**Minutes of the Pre-bid Meeting held on April 12, 2017 at 11.00 AM at Cochin SEZ Administrative Building,
Kakkanad, Cochin**

**Design, Engineering, Supply, Installation, Testing, Commissioning and Operation & Maintenance (O&M) for
5 Years of Zero Liquid Discharge (ZLD) System with Reverse Osmosis (RO) including Reject Management
for Common Effluent Treatment Plant (CETP) in Cochin Special Economic Zone (CSEZ), Kakkanad, Cochin**

NIT No.: WAP/H-3082/CSEZ/IWMS/ZLD/2017 dated the April 03, 2017

Drawing 1: Layout of Existing CETP at CSEZ Cochin

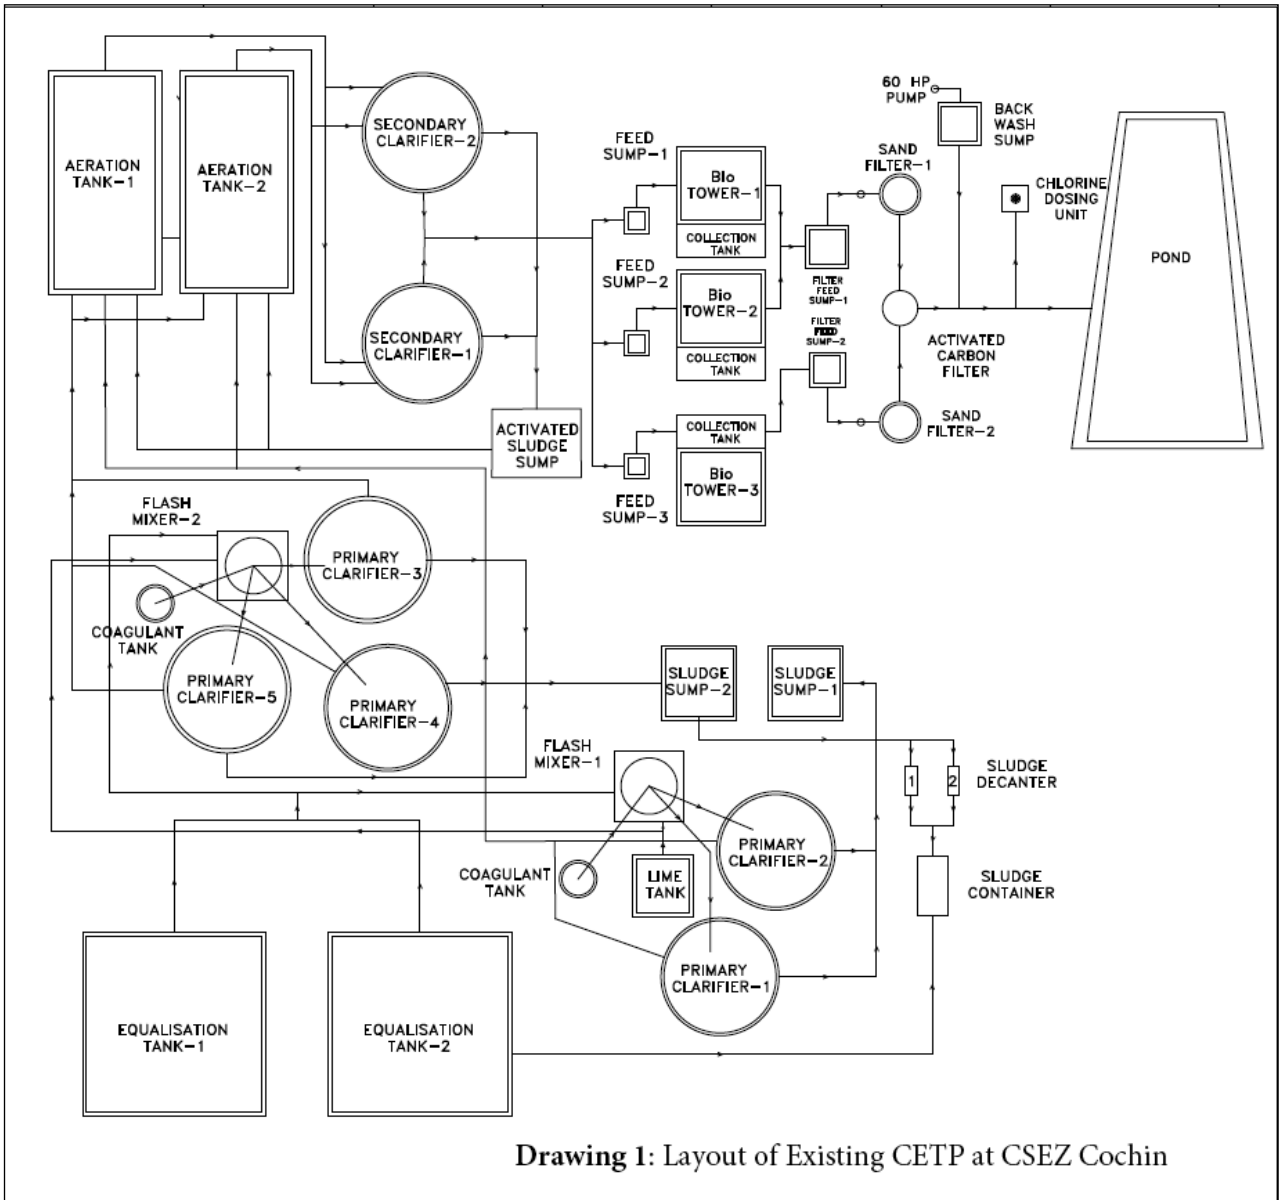
16		Please provide the Treatment Scheme in the Existing ETP	Please refer Annexure – 2.

17		Please clarify whether the proposed ZLD plant will be located within the Existing ETP area or at some other location. Please provide the Overall Plot plan with clearly indicating us the area available for the proposed ZLD system & the Existing ETP	Yes, the proposed ZLD plant shall be located near the existing CETP area.
18		Please provide the End Water application of the Treated Water	For industrial reuse for multi-product units like textile, ceramics, seafood processing, rubber etc. located within the Zone.
19	Agitated thin film dryer (ATFD)	Please confirm the Moisture content of solids at outlet of ATFD.	Approximately 8 to 10%
20	Battery Limits	Please provide the ZLD Plant battery limit for all Mechanical, Electrical & C&I.	The tentative Battery Limits shall be between 5 – 10 m. The exact limits shall be known after the finalisation of site.
21		Please confirm the Plant Operating hours for which the plant has to be designed	24 hours.
